R-4

**Open Letter to Mr. Asi Cymbal  
regarding the density of Marina Lofts**

December 17, 2012

Number of units in Riverfront Condominiums

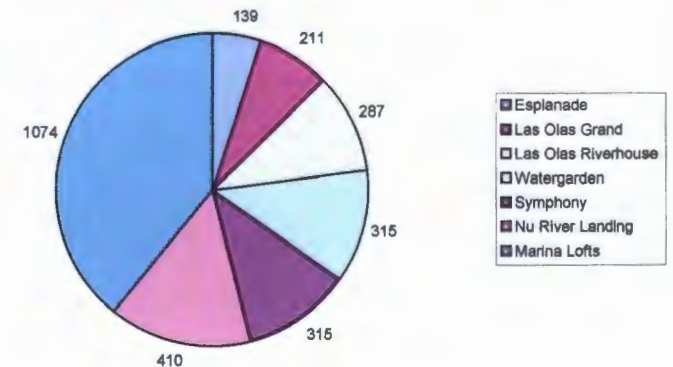
The units/acre of 179 would be 50% higher than the above average of 121  
 The # units is 725 if the above average units/acre of 121 is assumed  
 The # units drops to 628 when land for the Riverwalk is excluded  
 The # units drops to 459 when additional land for the boat storage area is excluded  
 The # units drops to 399 when additional land for the park area is excluded
